**FINAL DRAINAGE REPORT
FOR
SADDLEHORN RANCH – FILING 5 EARLY GRADING**

**September 1, 2022
Project No. 25142.07**

El Paso County PCD File No.:
EGPXXX
EGP226

EARLY GRADING PROPOSED
DRAINAGE MAP
SADDLEHORN RANCH FILING 5
JOB NO. 2514207
8/26/2022
SHEET 1 OF 2

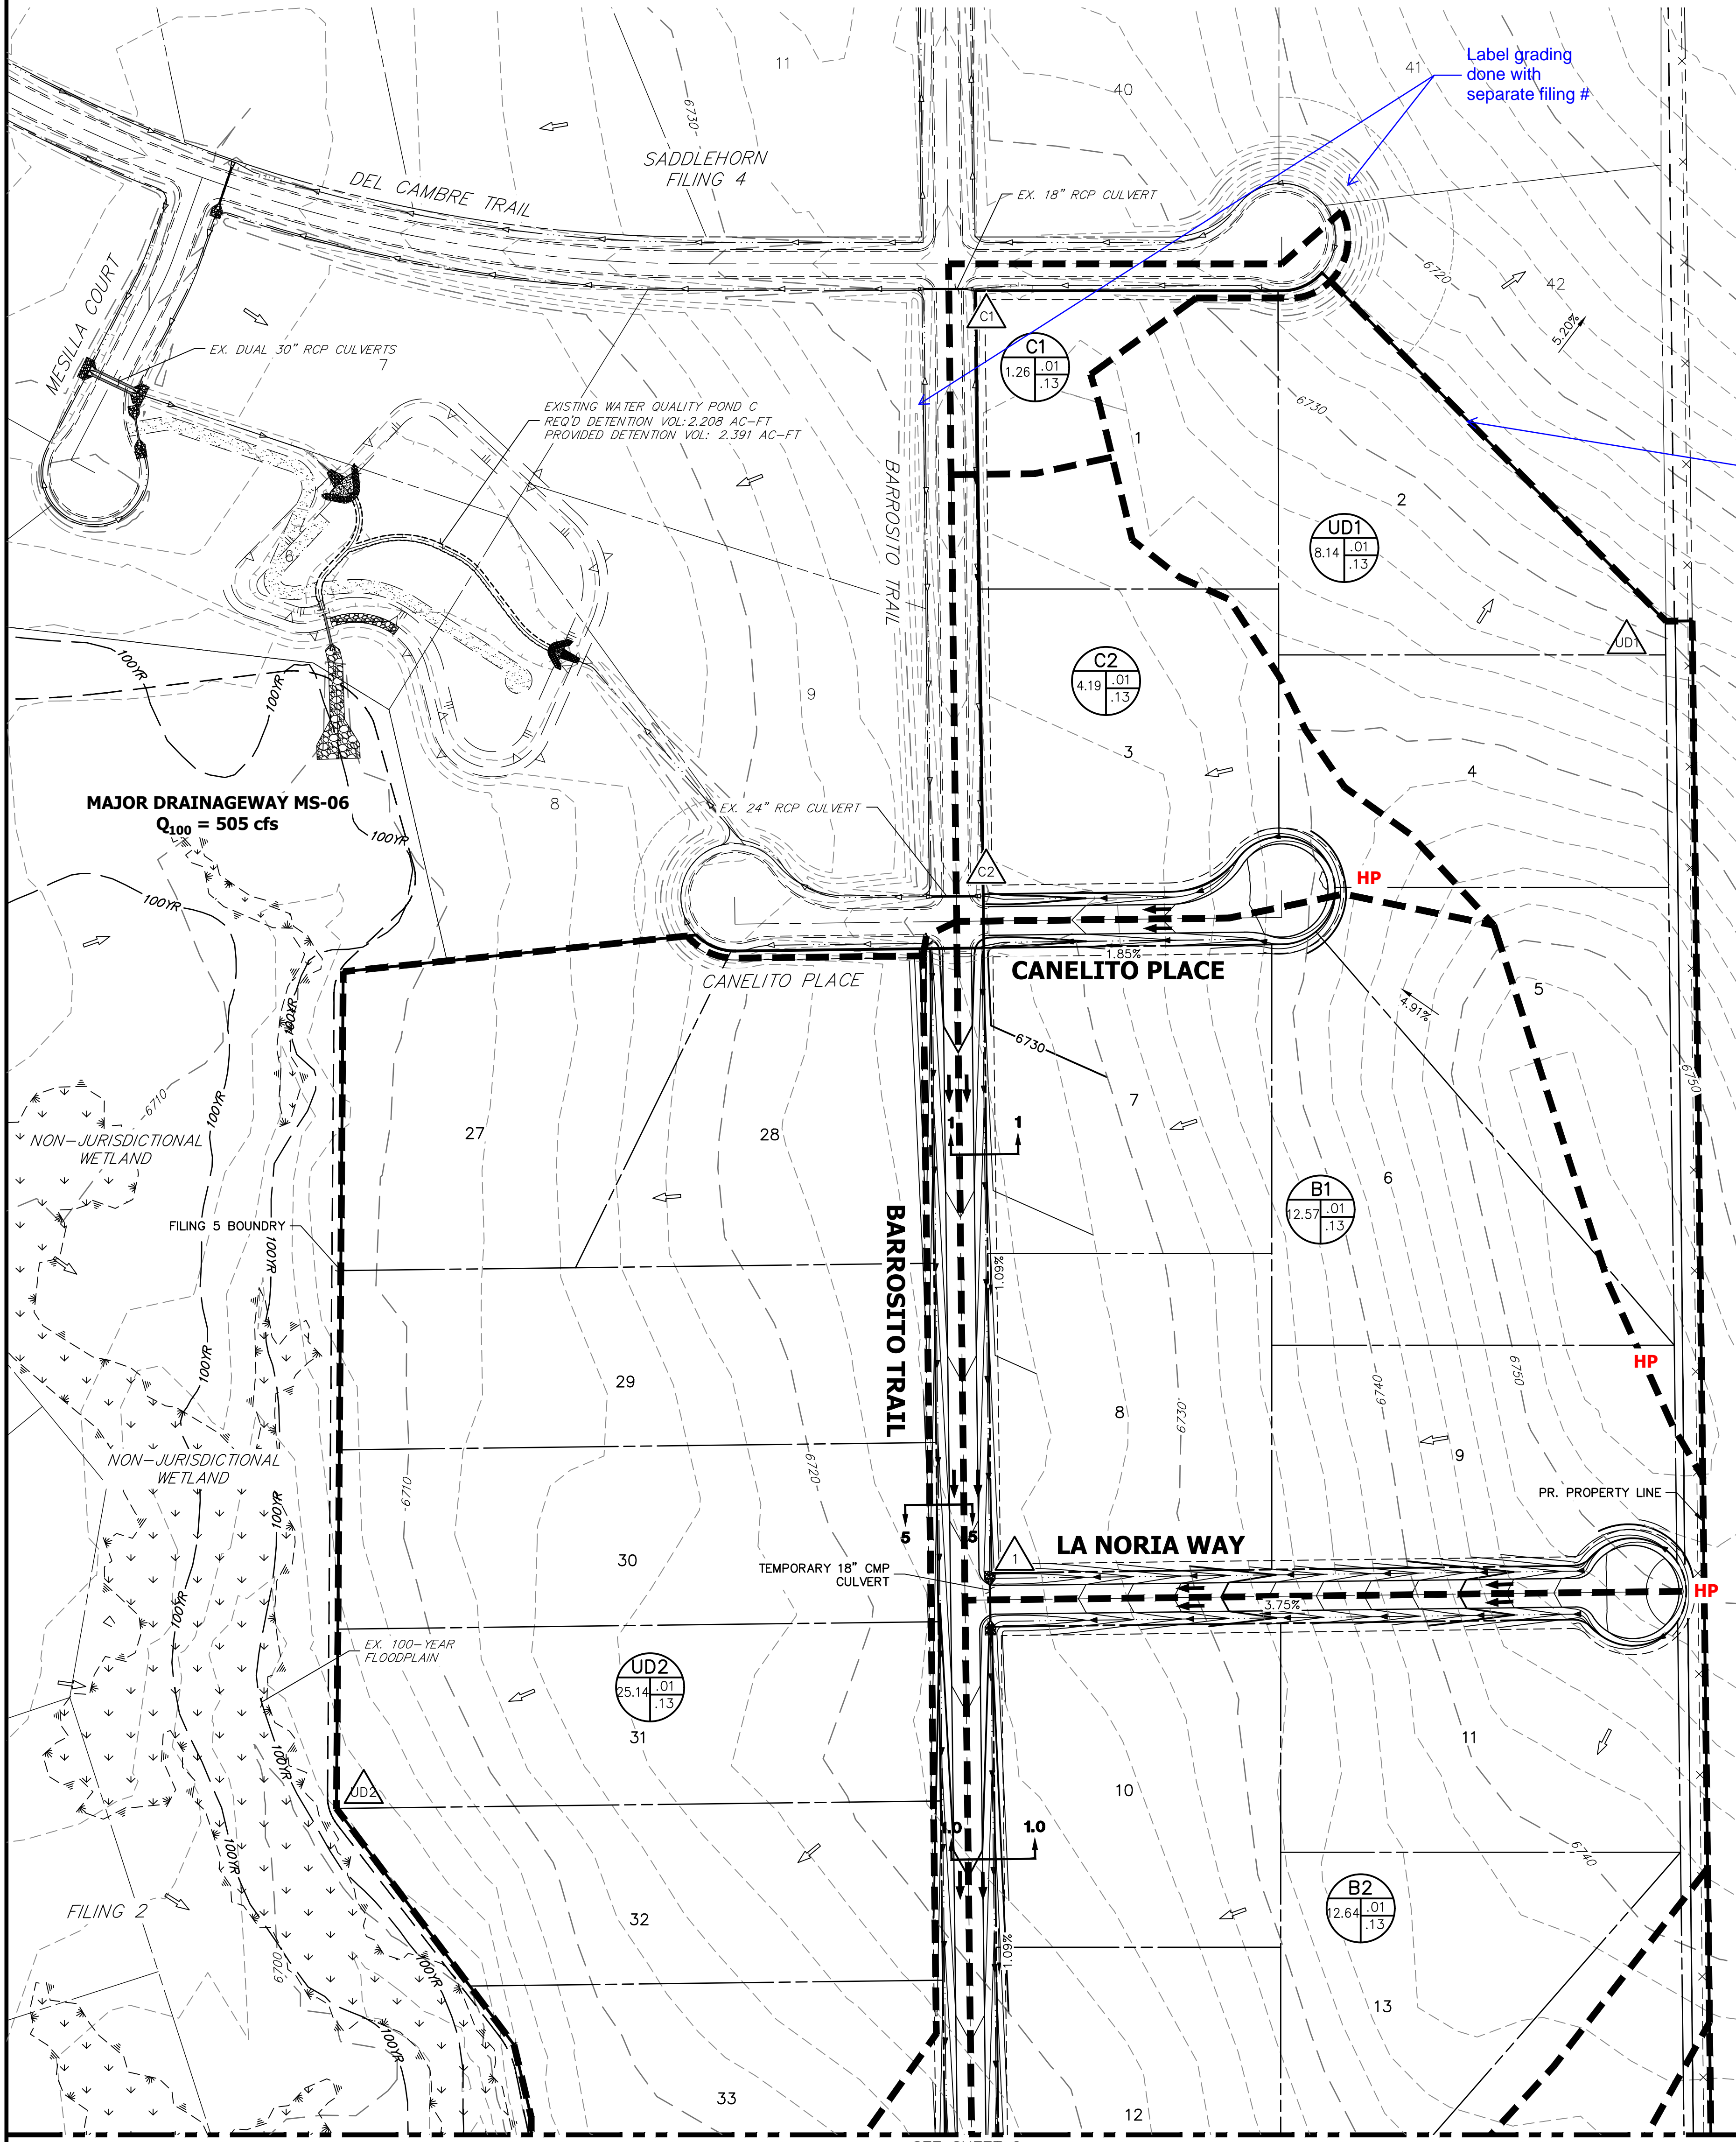
Label basin ended at property line for analysis purposes

Label adjacent property owners

Provide offsite basins

EARLY GRADING PROPOSED
DRAINAGE MAP
SADDLEHORN RANCH FILING 5
JOB NO. 2514207
8/26/2022
SHEET 2 OF 2

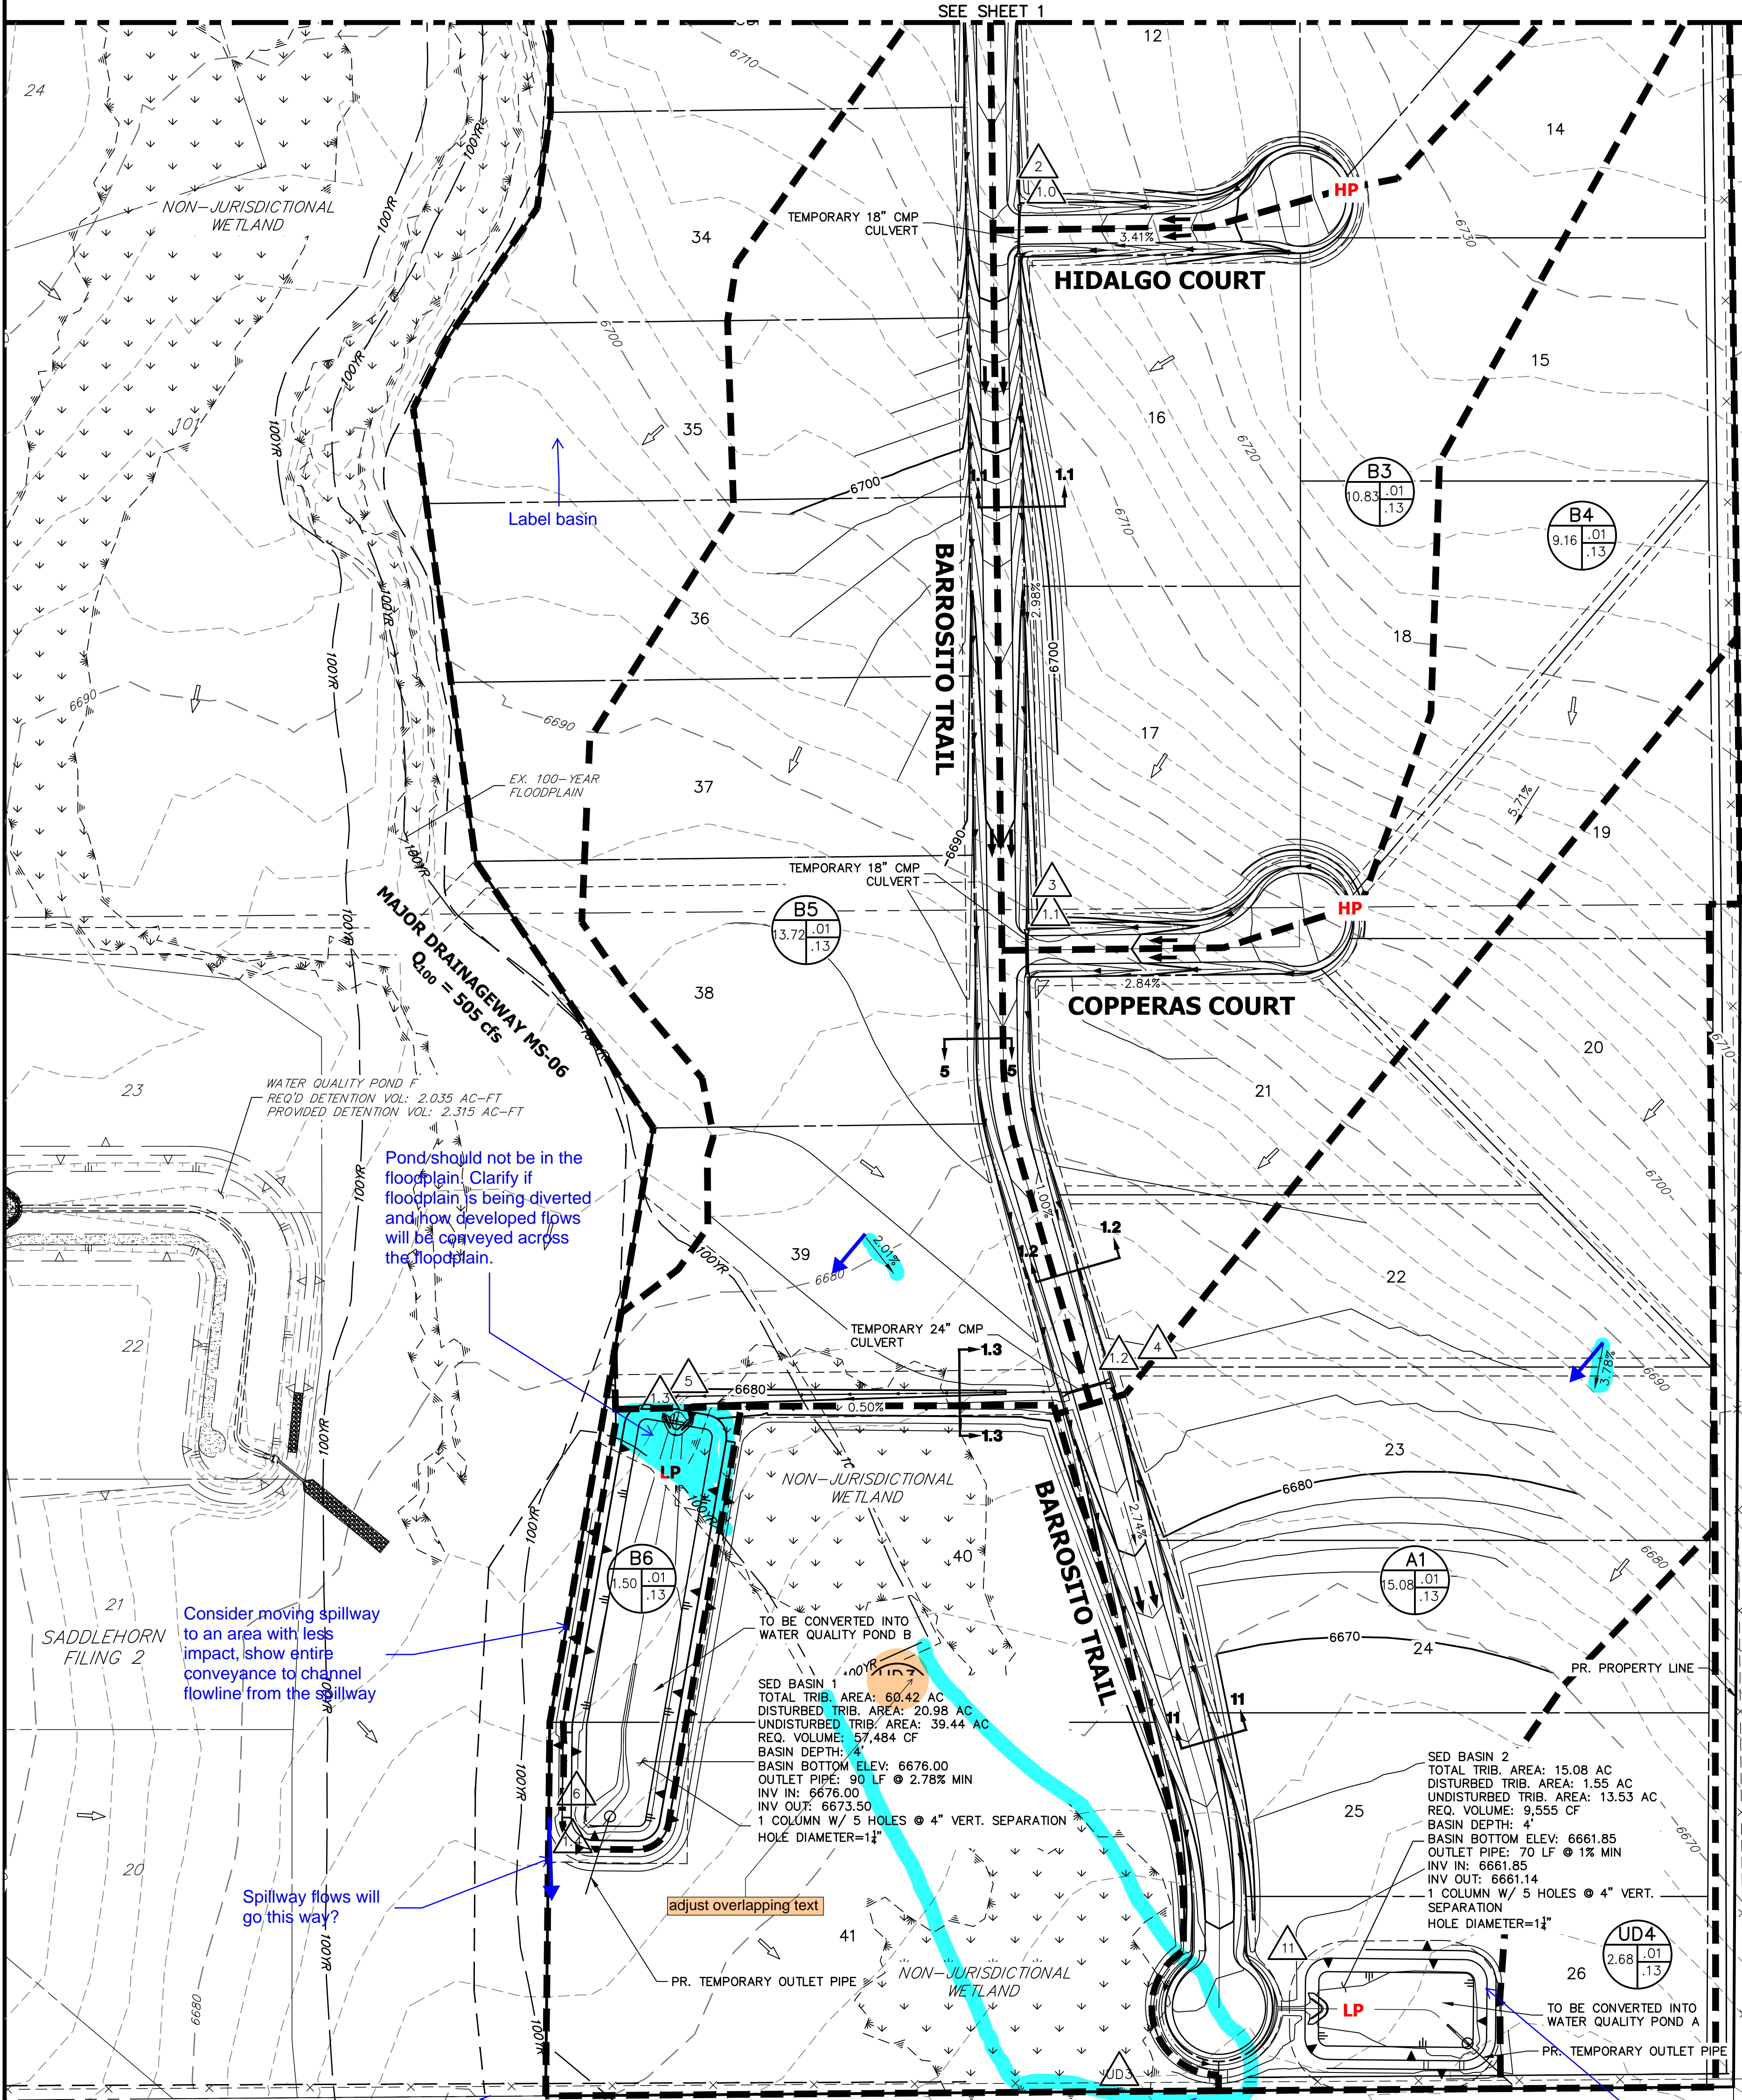
Provide offsite basins

Pond should not be in the floodplain. Clarify if floodplain is being diverted and how developed flows will be conveyed across the floodplain.

Consider moving spillway to an area with less impact, show entire conveyance to channel flowline from the spillway

MS4 PERMIT EXCLUSION AREAS
SADDLEHORN RANCH FILING 5
JOB NO. 25142.07
9/1/2022
SHEET 1 OF 1

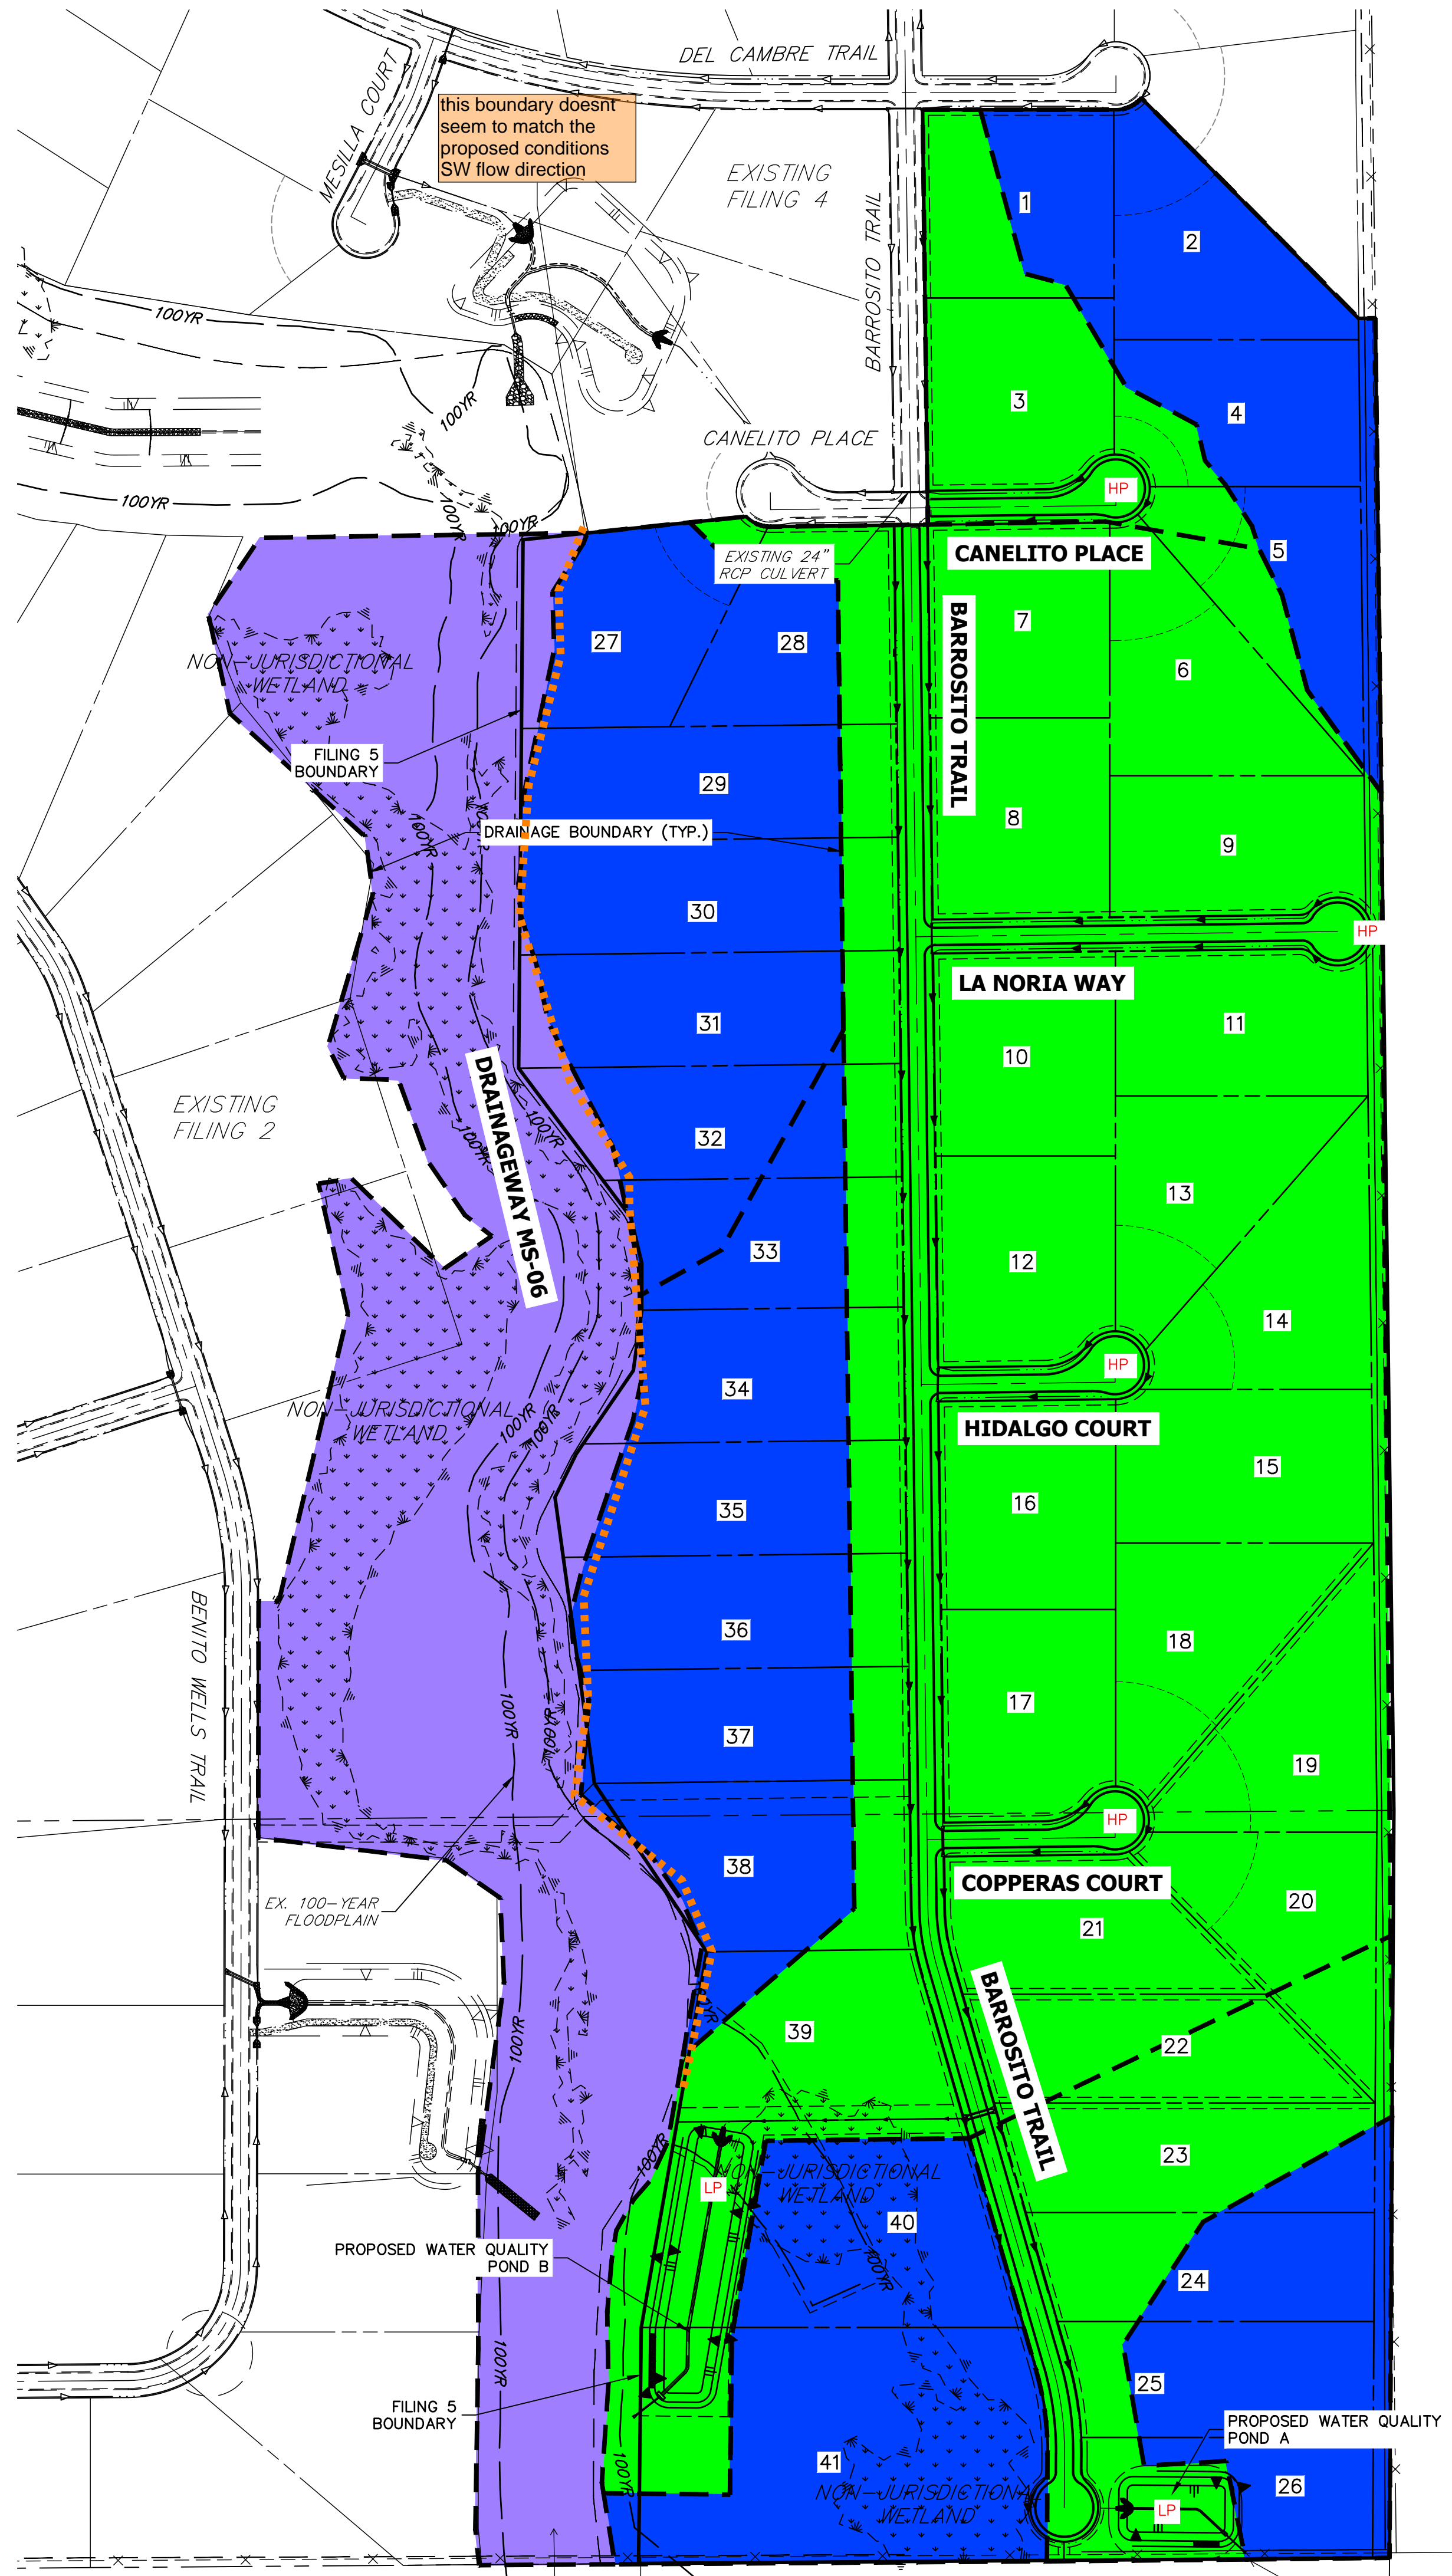
show offsite discharge path from outlet to drainageway
